The Commission has issued the enclosed Amendment No. 22 to Provisional Operating License No. DPR-18 for the R. E. Ginna Nuclear Power Plant in response to your request dated October 11, 1978, (transmitted by letter dated October 16, 1978).

The amendment consists of changes to the Technical Specifications relating to the offsite and onsite management organization.

Amendment No. 22
License No. DPR-18

ATTACHMENT TO LICENSE AMENDMENT NO. 22

Figure 6.2-2

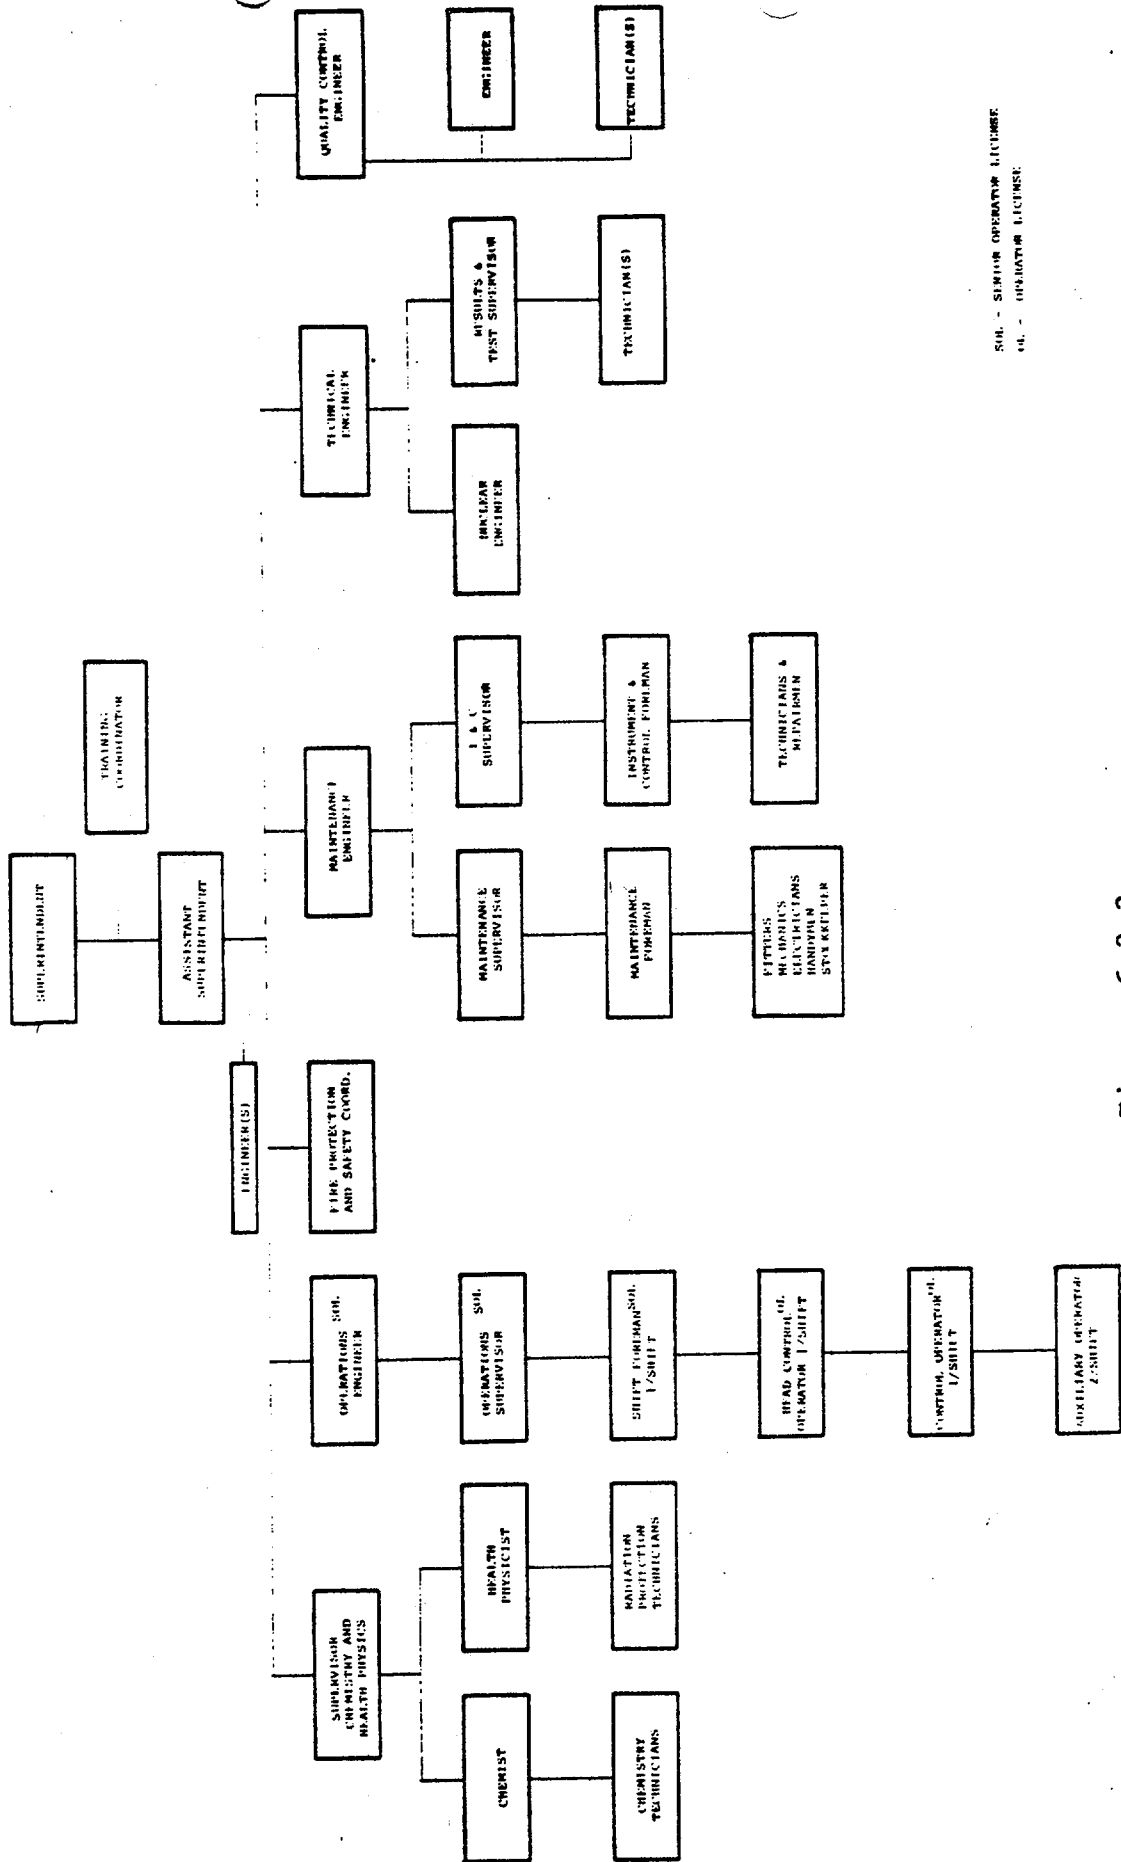
5. The Results and Test Engineer position would be changed to the Results and Test Supervisor. This position and the nuclear engineer would then report through a new position, Technical Engineer, to the Assistant Superintendent instead of directly to the Assistant Superintendent as in the organizational structure currently reflected in the Technical Specifications. Also a new position, Fire Protection and Safety Coordinator reporting to the Assistant Superintendent would be created. The position of Office Supervisor would be deleted; and
6. The Plant Onsite Review Committee (PORC) would be expanded to include the new position of Technical Engineer and changed to reflect a new position title, Results and Test Supervisor, in place of the Results and Test Engineer.

Revise Appendix A Technical Specifications by removing the following pages and inserting the enclosed pages. The revised pages are identified by the captioned amendment number and contain vertical lines indicating the area of change.
